South Coast Air Quality Management District  
21865 Copley Drive, Diamond Bar, CA 91765-4182  
(909) 396-2000 • [www.aqmd.gov](http://www.aqmd.gov)

**Re: Supplemental Letter for the Appeal filed by the South Coast Air Quality Management District of the Final Environmental Impact Report (FEIR) prepared for the Southern California International Gateway (SCIG) Project (Appeal No. 13-0295-S6)**

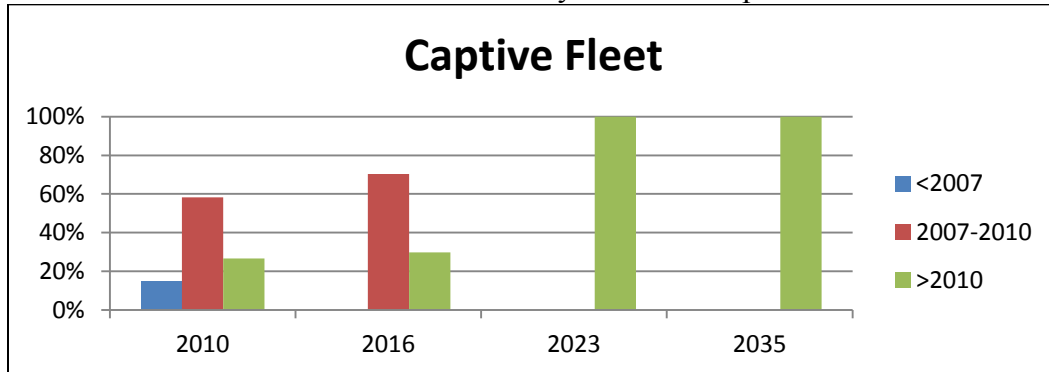
Another important factor is that the modeling analysis was not conducted for individual years. Instead all of the worst-year emission rates from each of the thousands of source were added together in a single amalgamated model run for each alternative. For example, the 2023 emissions from Fast Lane cargo handling equipment were modeled at the same time as the 2016 Fast Lane onsite captive truck idling emissions. The resulting model output then does not represent a real potential impact.

For Project Alternative analyses, this approach is sometimes used as a conservative method to ensure that worst case impacts are being evaluated. However, in this EIR the No Project Alternative also used this approach. Because of the high baseline emissions in this industrial area, this analytic approach would yield modeled concentrations that are substantially higher than would be expected in the future. Future emissions are expected to decrease because of already approved tighter federal and state emission standards. While the Project Alternative modeling would be conservative, the No Project Alternative appears to be substantially more “conservative”, yielding an increment that overstates any potential project “benefits”. In fact, because of this modeling approach, it is not possible to tell if the Project Alternative improves air quality in every year. It is possible that in some years the Project Alternative may have worse impacts than the No Project Alternative when considering this factor along with others mentioned in this and other letters.

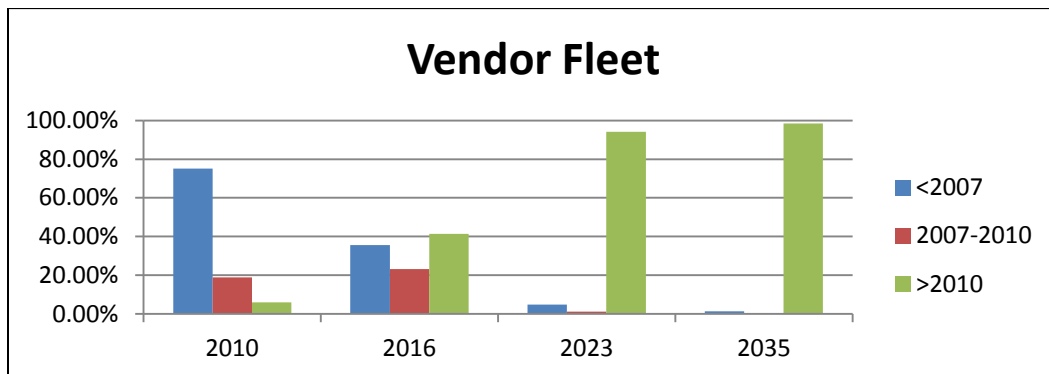
The emissions calculations for Cal Cartage show that approximately 600 trucks per day visit the site, of which 160 are part of their ‘Captive’ fleet. For the NO<sub>2</sub> analysis, the ‘Captive’ fleet is assumed to be made up of a mix of ‘port trucks’ that are all model year 2007 or newer, consistent with requirements of the Clean Air Action Plan. LNG trucks are generally 2010-compliant and have substantially lower NO<sub>x</sub> emissions than pre-2010 diesel trucks. The bar chart below shows the distribution of trucks from the EIR analysis of the ‘Captive’ fleets.

As can be seen in the chart, the majority of ‘Captive’ and ‘Vendor’ trucks through 2016 are not 2010 compliant. Hence NO<sub>x</sub> emissions are substantially higher than they should be in the No Project Alternative by ignoring these LNG trucks.

Further, the ratio of the ‘Captive’ fleet of 160 trucks and the remaining ‘Vendor’ fleet of 440 trucks appears to underestimate the size of the ‘Captive’ fleet. SCAQMD staff confirmed with Bob Lively from Cal Cartage (5/7/2013) that they currently operate a fleet of about 310 LNG trucks. If this is the case, then LNG trucks represent a much larger fraction of the trucking operation at Cal Cartage than was assumed in the EIR. This ratio is important because for the Health Risk Assessment analysis, the ‘Captive’ fleet is assumed to be 100% LNG. The ‘Vendor’ fleet in the EIR is made up of a mix of trucks that are equal to the average fleet of trucks within the SCAQMD (see bar chart below).

As seen in the chart above, more than one third of this fleet is assumed to be older than 2007 model year until after 2016, and hence would not have a Diesel Particulate Filter. As Diesel
